CONSTRUCTION CERTIFICATION REPORT

ALLTIFT LANDFILL SITE

NYSDEC Site No. 9-15-054

RAMCO STEEL SITE

PUMP STATION AND METERING VAULT DETAIL
SCALE: 1/2" = 1'-0"

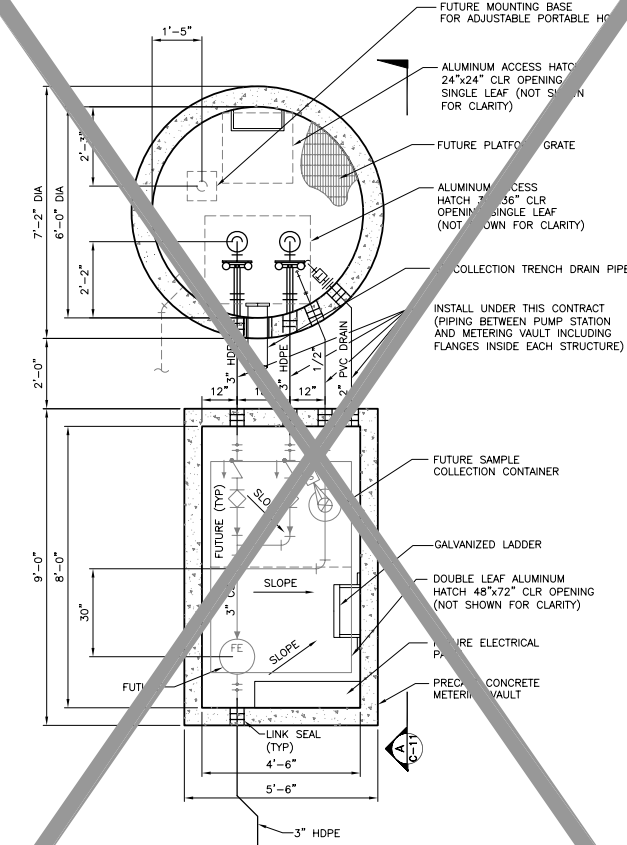
SEE C-16 FOR REVISED DETAILS.
DELETED PER FIELD CHANGE FC009.

PUMP STATION AND METERING VAULT SECTION
SCALE: 1/2" = 1'-0"

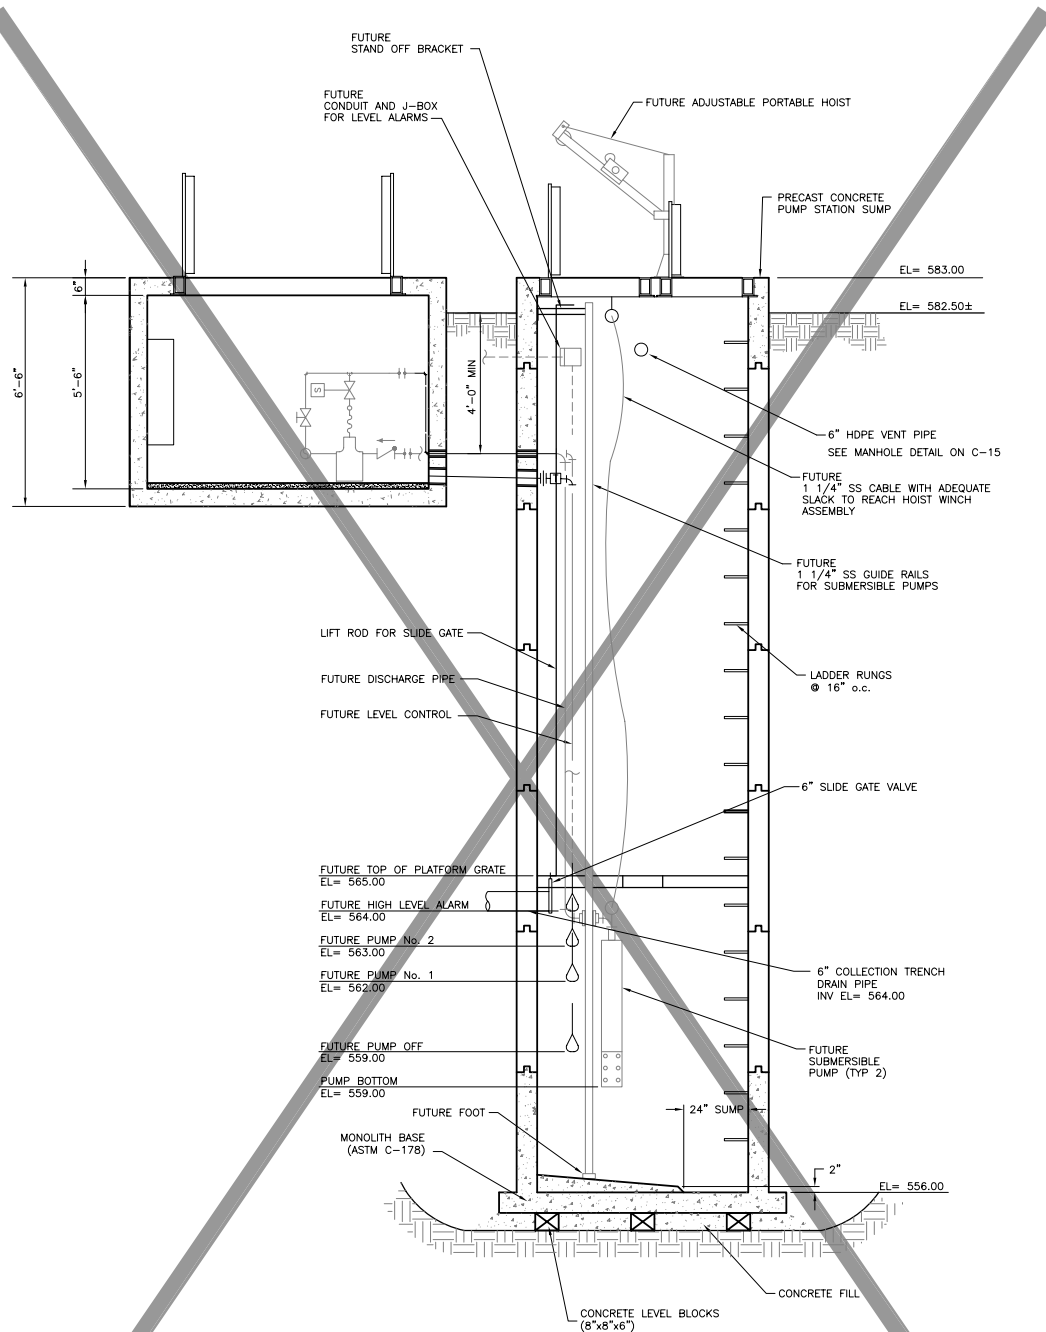
SEE C-16 FOR REVISED DETAILS.
DELETED PER FIELD CHANGE FC009.

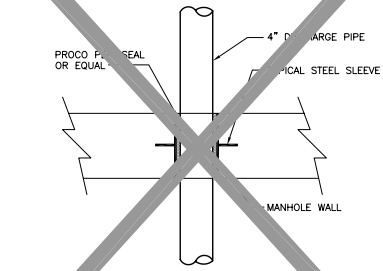
SEE C-16 FOR REVISED DETAILS.
DELETED PER FIELD CHANGE FC009.

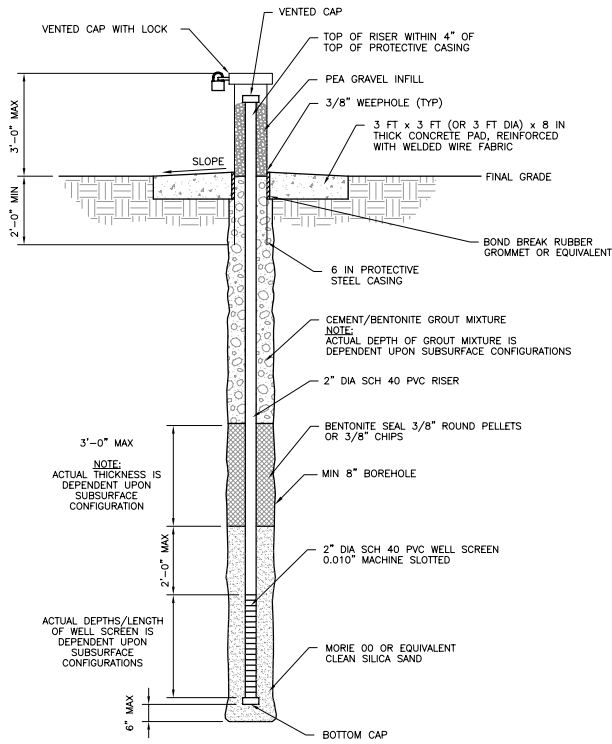
SEE C-16 FOR REVISED DETAILS.
DELETED PER FIELD CHANGE FC009.

25
C-08
25
C-09
PIEZOMETER DETAIL
NOT TO SCALE
(TYPICAL FOR PIEZOMETERS PZ-1 THROUGH PZ-14)

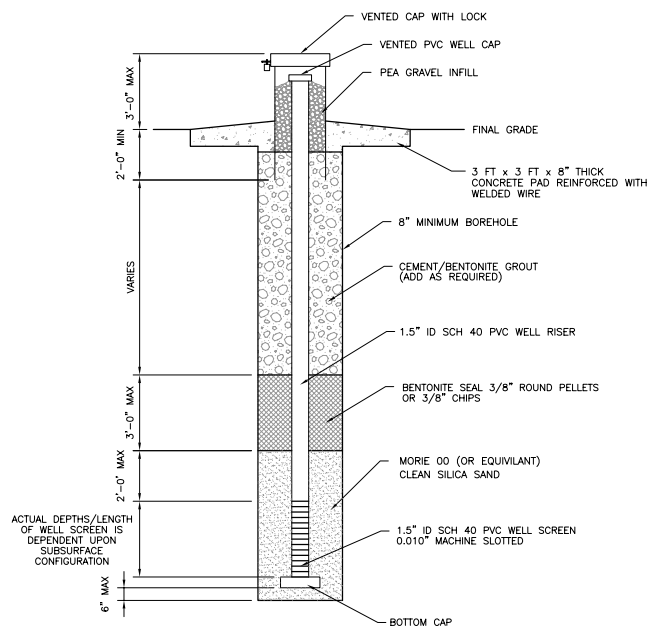
SEE C-16 FOR REVISED DETAILS.
DELETED PER FIELD CHANGE FC009.
